SERVICE UPDATE SEMINAR
2016-2017

KOHLER Engines

999cc Electronic Governor Improvements

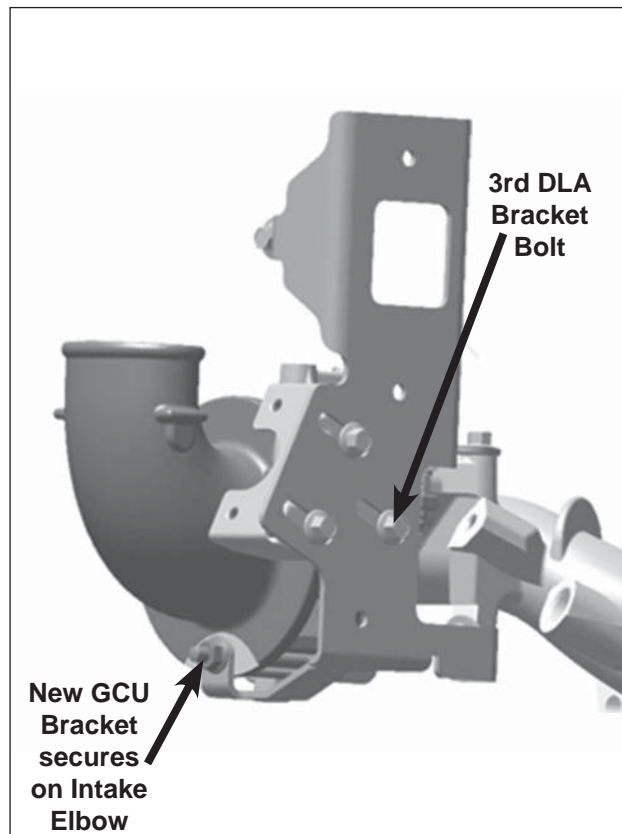
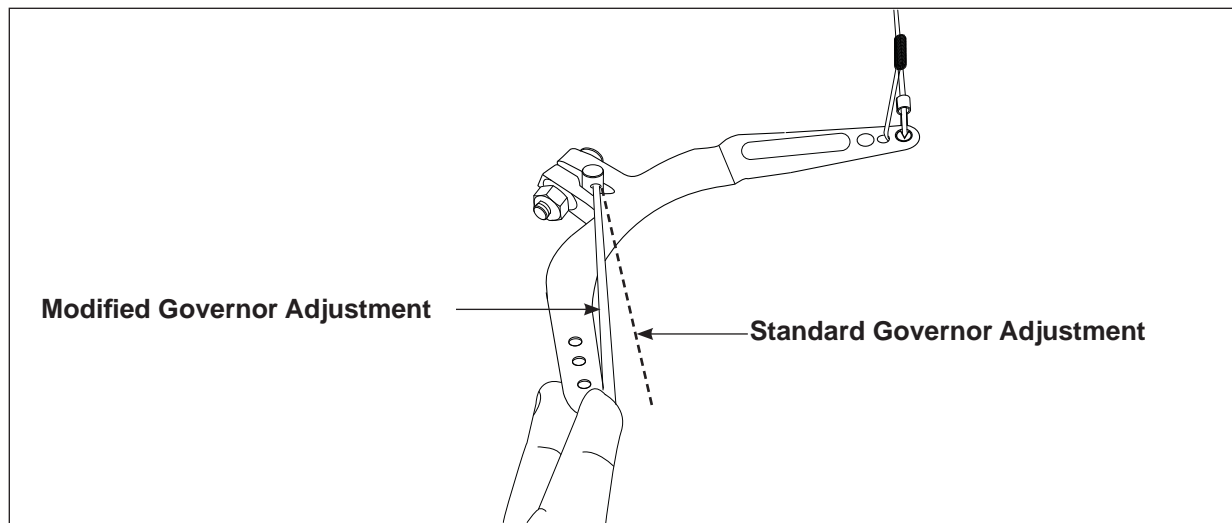
Service Bulletin 345 described the significant changes implemented for Model Year 2016, electronic governor equipped, 999cc engines. These changes improve reliability by reducing vibration and addressing fatigue/wear on critical components.

- **Redesigned bracket for electronic governor system.**
Fourth leg added for stability.
Extra mounting bolt added to Digital Linear Actuator (DLA) bracket for increased rigidity.
- **Improvements to the DLA.**
High performance grease applied internally that will not migrate or evaporate.
Larger ball bearing to improve resistance to vibration induced damage.
- **Rerouting of wires, harness, and the addition of shrink tubing to address stress on the wire connections.**
- **Improvements to Governor Control Unit (GCU).**
Redesigned housing to prevent breakage of mounting ears.
Gold terminals for increases connectivity.
Adhesive used to secure wiring harness to GCU to prevent wear of terminals.

Figure 1.

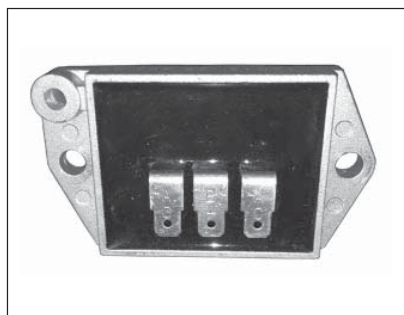
This latest rectifier-regulator (see Figure 1), has a ground lug and built-in over-voltage protection that is self-resetting. The over-voltage protection prevents possible damage to other electrical components if an engine is jump-started. This regulator is especially recommended for use on EFI engines, **except** on Walker mowers where there is insufficient clearance for it to be used. When replacing an earlier regulator, like part number 25 403 05 (see Figure 2), just use the new regulator. To replace an older regulator (see Figure 3), use kit **24 755 144-S**, which includes the new regulator and the necessary conversion pieces.

Figure 1. Identifying E-GOV Service Kit Components.

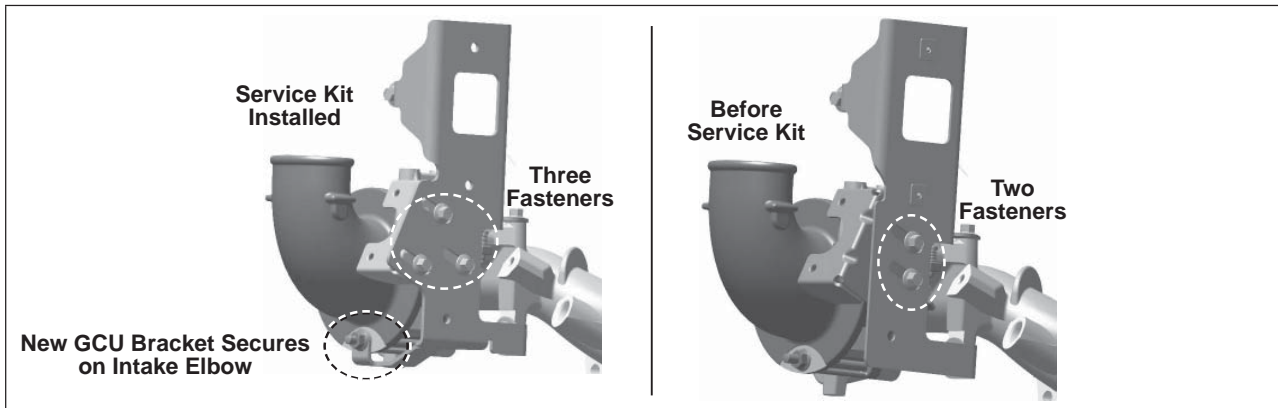
If the E-GOV update service kit has already been installed (as evidenced by Figure 1), and faults persist, this indicates the fault is not likely caused by the E-GOV system. Once the service kit has been installed, subsequent E-GOV system repairs will be performed with replacement components as needed, not another kit.

Figure 2. New T-Fitting and New Line Assembly.

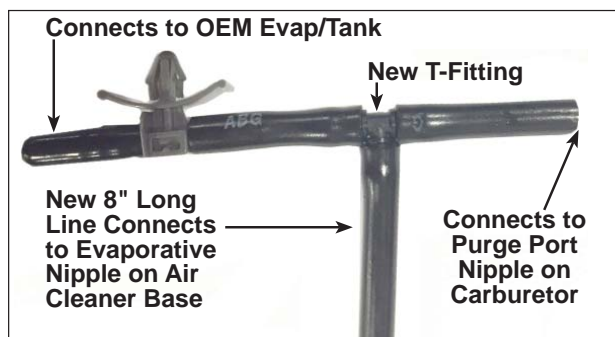
3. Install the new T-Fitting at the location of the cut line. Take the new 25 326 28-S 14" long line and cut it to an 8" length. Install and route the new 8" long line as shown in Figure 2.

Figure 4. Connect New 8" Long Evap Line to Air Cleaner Base.

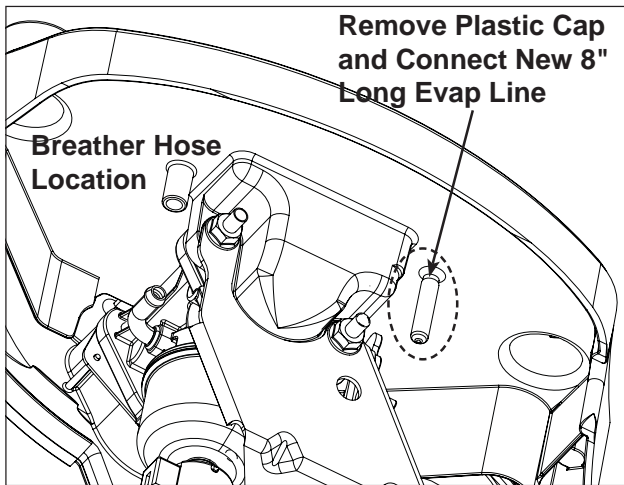
5. Route the new 8" long evap line from the T-Fitting to the plugged port on the air cleaner base. Remove and discard the plastic cap at that location. See Figure 4.

Figure 1. Damaged Discs.

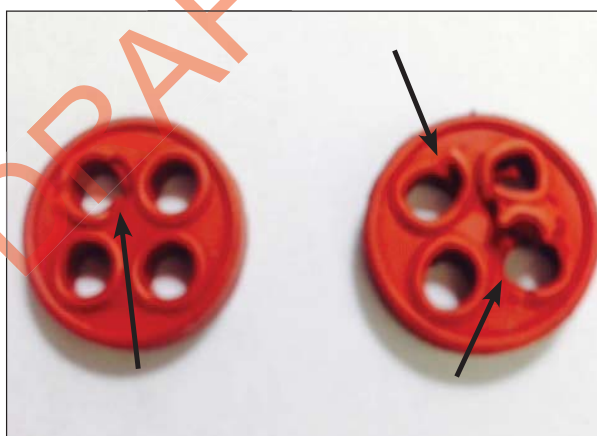
The restricted fuel flow is due to shut-off valve disc damage or deterioration caused by an improper casting that can put excess pressure on the disc during rotation, as well as poor disc resilience. See Figure 1.

Both of these issues have been corrected in engines built after **June 3, 2015**, serial number **45154XXXXX**. At this same time, carburetor kit part number 17 853 66-S, was updated with a more resilient disc material and a casting change that provides proper tolerance.

If an issue is encountered, ensure proper fuel flow from the tank. If it is determined to be an issue with restricted fuel flow due to the damage to the disc, a complete carburetor replacement is recommended. Order carburetor kit 17 853 66-S from your source of supply.
